Re: West Buffalo B Unit
Clarkson #2-26H injection pressure
Sections 26 T21N-R03E
Harding Co., SD

IN THE MATTER OF THE APPLICATION OF CITATION OIL & GAS CORP., HOUSTON, TEXAS, TO INCREASE THE MAXIMUM INJECTION PRESSURE AT THE EXISTING CLARKSON 2-26H INJECTION WELL LOCATED IN THE SW ¼ NW ¼ SECTION 26, TOWNSHIP 21 NORTH, RANGE 3 EAST, IN THE WEST BUFFALO "B" RED RIVER UNIT, HARDING COUNTY, ABOUT 15 MILES NORTHWEST OF BUFFALO, SOUTH DAKOTA.	NOTICE OF RECOMMENDATION FOR MAJOR MODIFICATION TO A PERMIT TO INJECT OIL AND GAS CASE NO. 17-2012
---	--

FIG #1

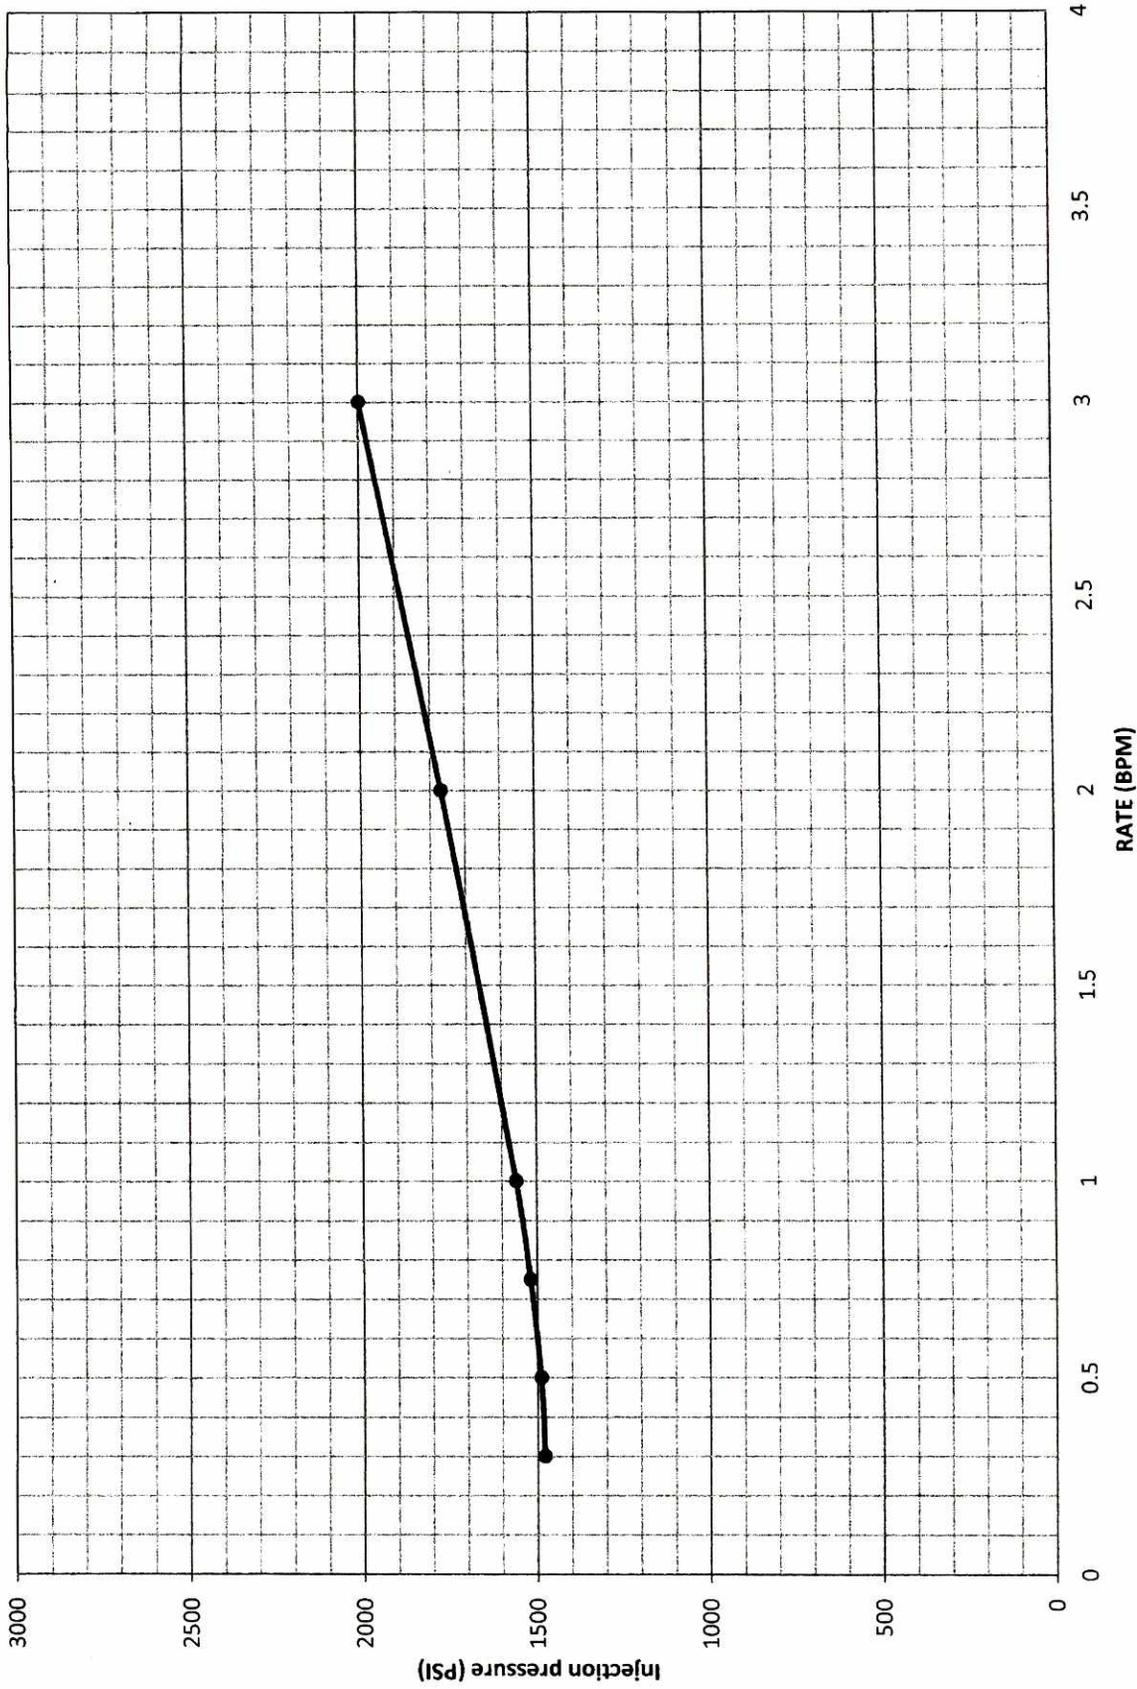
COGC performed a step rate test on the Clarkson #2-26H (**FIG #1** attached) on July 18th, 2012. The test was performed in 5 minute step intervals ranging from rates of 0.3 bpm to 3 bpm. Typical step rate results with injection pressure plotted versus rate show two straight line trends with the first trend line possessing a steeper decline representing matrix injection. The second trend line is typically shallower and characterizes fracture extension pressures. The intersection point of the two lines is used to estimate fracture extension pressure. The plotted results for the first step rate for the Clarkson #2-26H (**FIG #1**) do not exhibit a typical step rate trend and the straight line trend indicates that this step rate did not achieved a high enough rate to fracture the formation. Therefore, a second step rate test was performed on August 29th, 2012 (**FIG #2** attached) with 5 minute step intervals ranging from 1 bpm to 5.5 bpm. The pressure and rate data from the first step rate and second step rate test were merged and plotted accordingly (**FIG #3** attached). **Table #1** on **FIG #3** contains the averaged rates and averaged surface injection pressures during the step rate. The results from the merged step rate analysis remain the same as there are 2 distinct slopes but the trend is the inverse of a typical step rate plot. The line plotted in **FIG #3** exhibits a slight exponential trend and then deviates to an increasing linear trend. The point of deviation on this trend line corresponds to 2010 psi surface pressure or the requested

authorized maximum injection pressure. This deviation point corresponding to 2010 psi is not to be confused with the parting pressure of the formation.

FIG #4

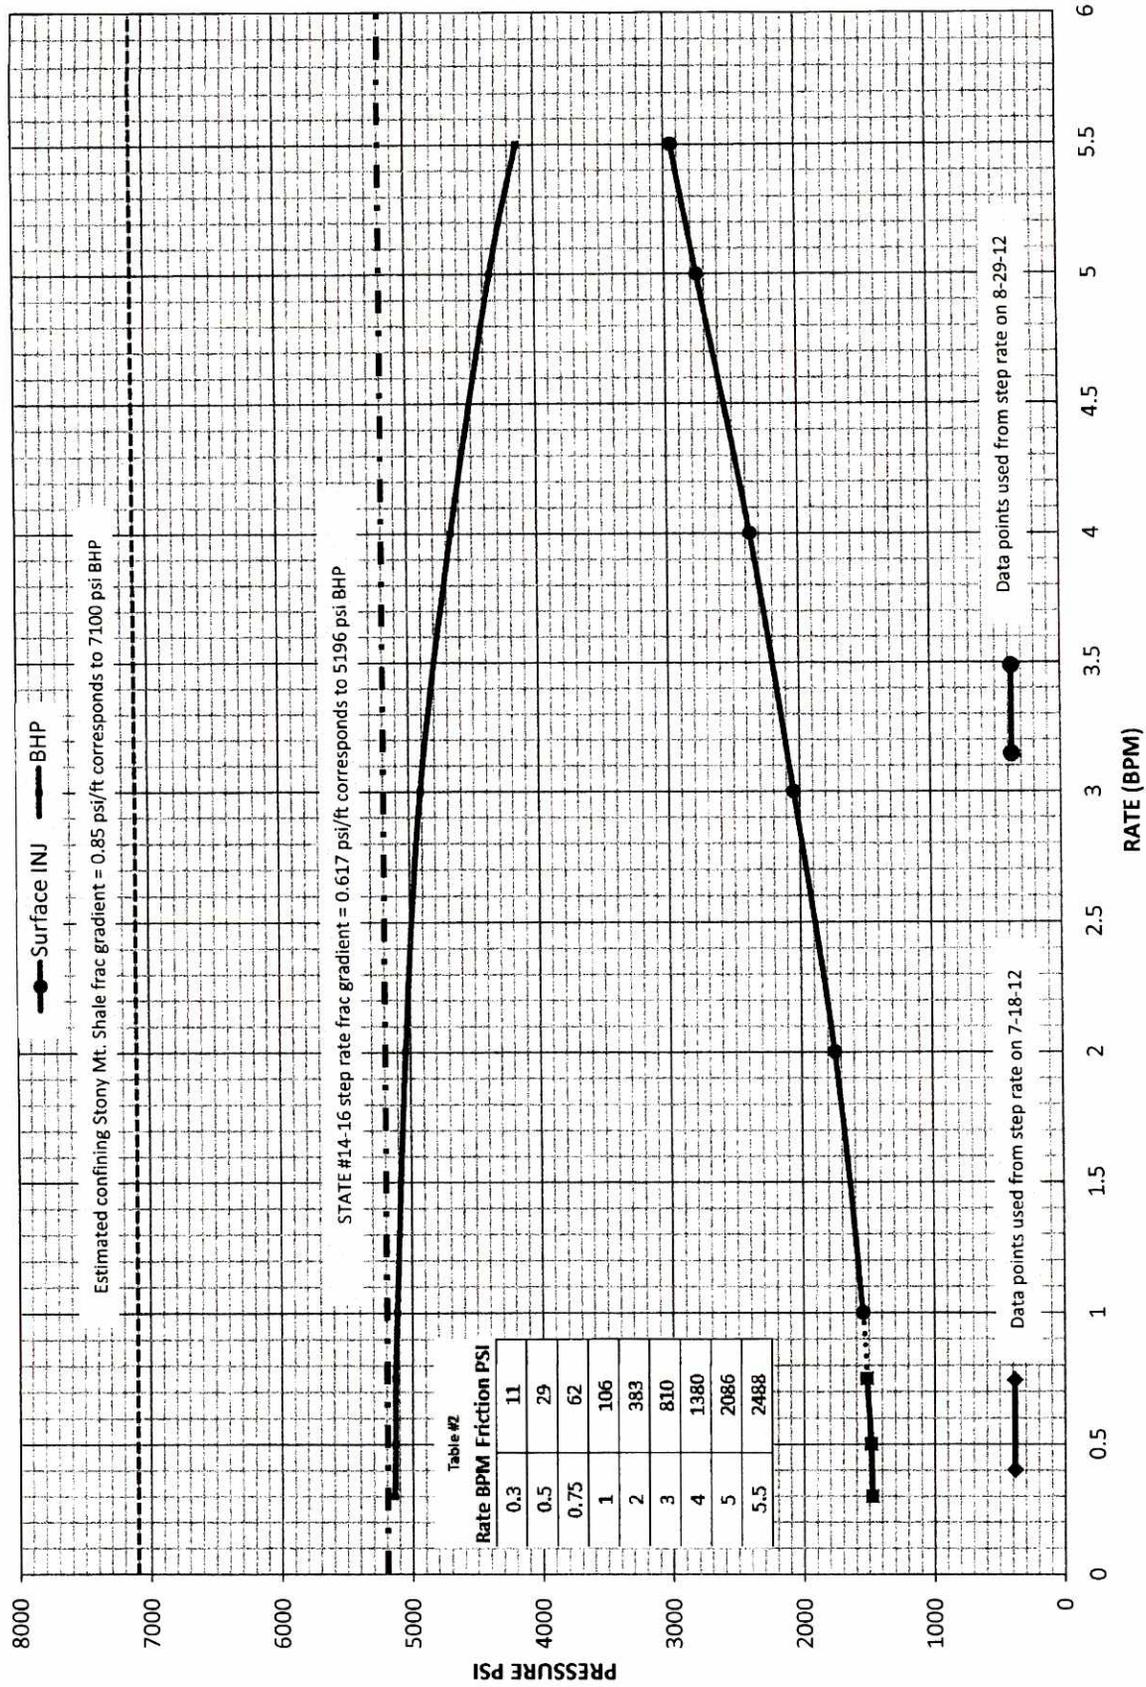
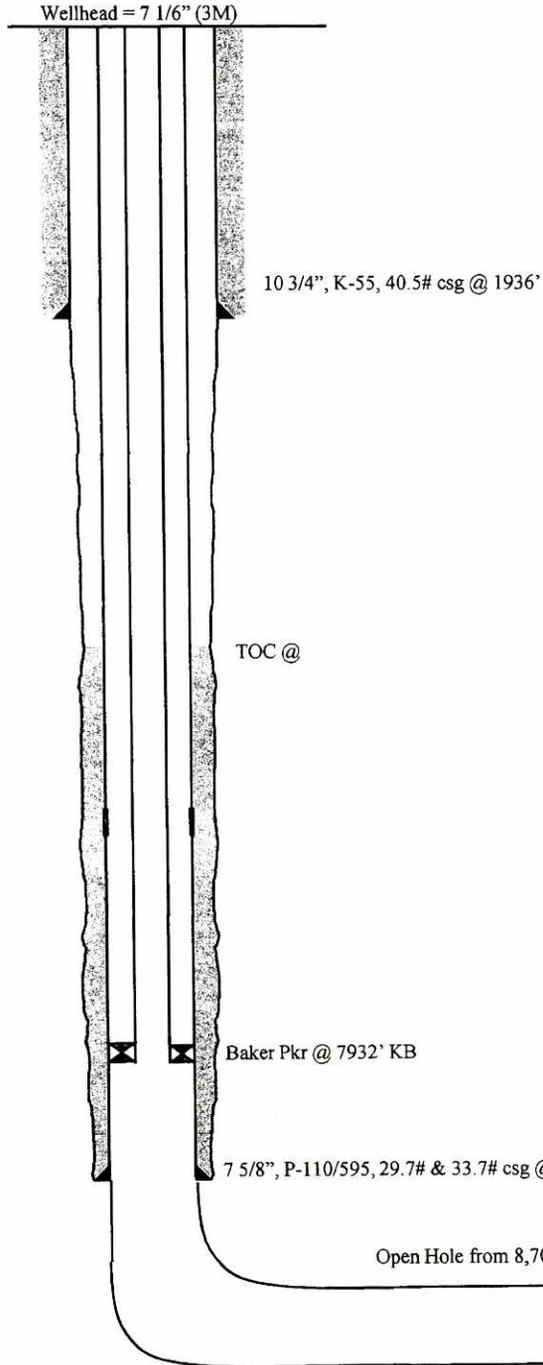
The Clarkson #2-26H step rate results reveal that much higher injection rates will be required to exceed the parting pressure of the formation. **FIG #4** plots the surface injection pressure and the bottom hole pressure (BHP) versus rate. **Table #2** on **FIG #4** contains the calculated friction pressures (P_f) at corresponding step rates. P_f was calculated using the imperial form of the Hazen-Williams equation.

Note the trend of the BHP pressure curve on **FIG #4** and that increasing the rate lowers the BHP due to increasing friction pressure. The black dashed line represents the bottom hole fracture pressure based on a fracture gradient of 0.617 psi/ft. The fracture gradient was derived from the original State #14-16 step rate and falls in line with estimated fracture gradients throughout the field. The bottom hole fracture pressure for the Clarkson #2-26H = (Fracture gradient x TVD of the lateral) = (0.617 psi/ft x 8422 ft) = 5196 psi. The BHP's fall below this line verifying that current and requested maximum injection pressures will not meet or exceed the estimated fracture pressure of the formation. Furthermore, the top confining zone (Stony Mt. Shale) will typically have a fracture gradient of 1.0 psi/ft or greater. However, the red dashed line represents a bottom hole fracture pressure (7100 psi) of the Stony Mt. Shale assuming a conservative fracture gradient of 0.85 psi/ft. **FIG #4** illustrates that current and requested maximum injection pressures not only fall below the Red River B parting pressure but also below the confining zone parting pressure. Therefore, it is reasonable to conclude that horizontal injectors should be evaluated independently and utilizing vertical injection well step rate data will result in ultra-conservative injection pressures for horizontal injection wells.
